**Planning Appeal:
APP/X1355/W/23/3333600, land north and east of Sniperley Farm, Durham.**

STATEMENT OF CASE OF THE CITY OF DURHAM TRUST

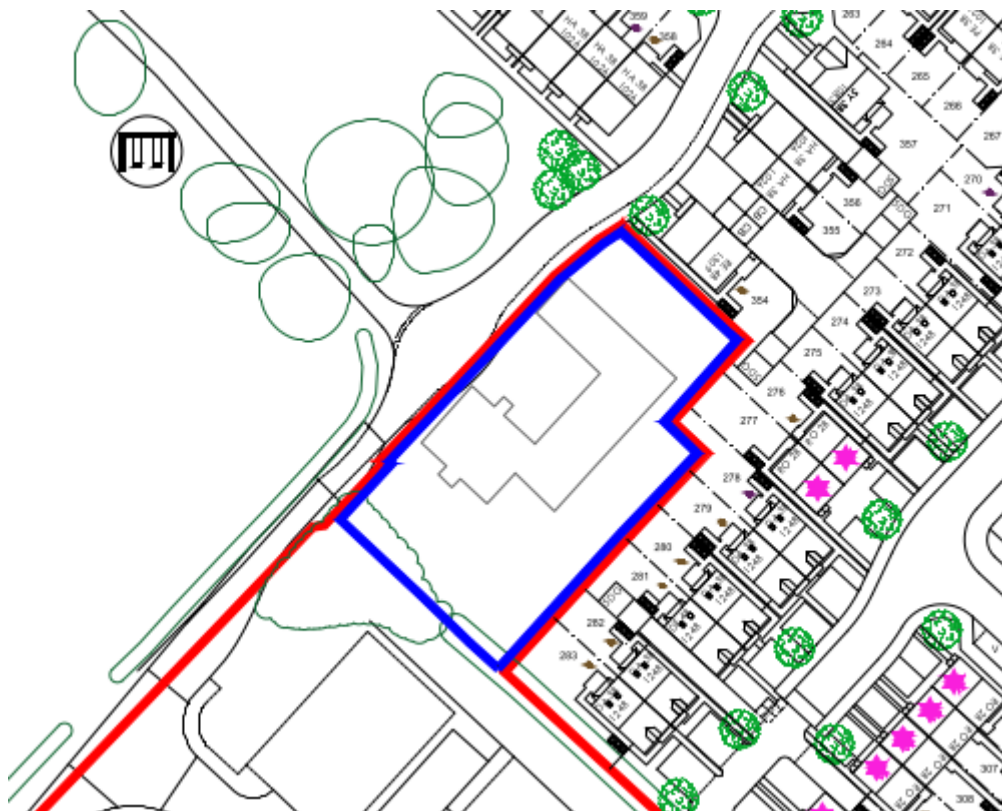
7. Regarding the specific setting of the Hall, the layout of the housing immediately to the north of the Hall (labelled "1" on the following excerpt, and outlined in a pink dotted line) has eight houses back onto the historic parkland with 1.8m close boarded fences. This does not have regard to the character or setting of the Hall. The housing in the area marked "2" on the excerpt is better, as it faces the Hall across public space. The housing density in the area labelled "3" may be reduced slightly compared to the rest of the development, but only by providing more substantial private gardens. The houses labelled "1" which are closest to the historic parkland are comparatively dense with much smaller gardens. The setting to Sniperley Hall is basic in concept and fails to positively enhance either the Hall or the new development. The partial open space buffer is minimal with no screening other than a new hedgerow, and the remainder of the boundary area is formed from relatively small rear gardens, failing Policy 29(l). The whole arrangement falls substantially below the design quality expected by the policy.

8. The Trust has overlaid sight-lines in light blue to the excerpt, demonstrating that it is not possible to see the whole Hall except at quite close range. The applicant has included only a single illustration in the Design and Access Statement (p. 63) showing a view from a point relatively close to the Hall. The layout appears to offer a very selective approach to protecting and enhancing only part of the setting to the Hall. The proposed development impinges on the view zone envisaged in the Durham County Council Masterplan (see also the Trust's main SoC, para. 37).
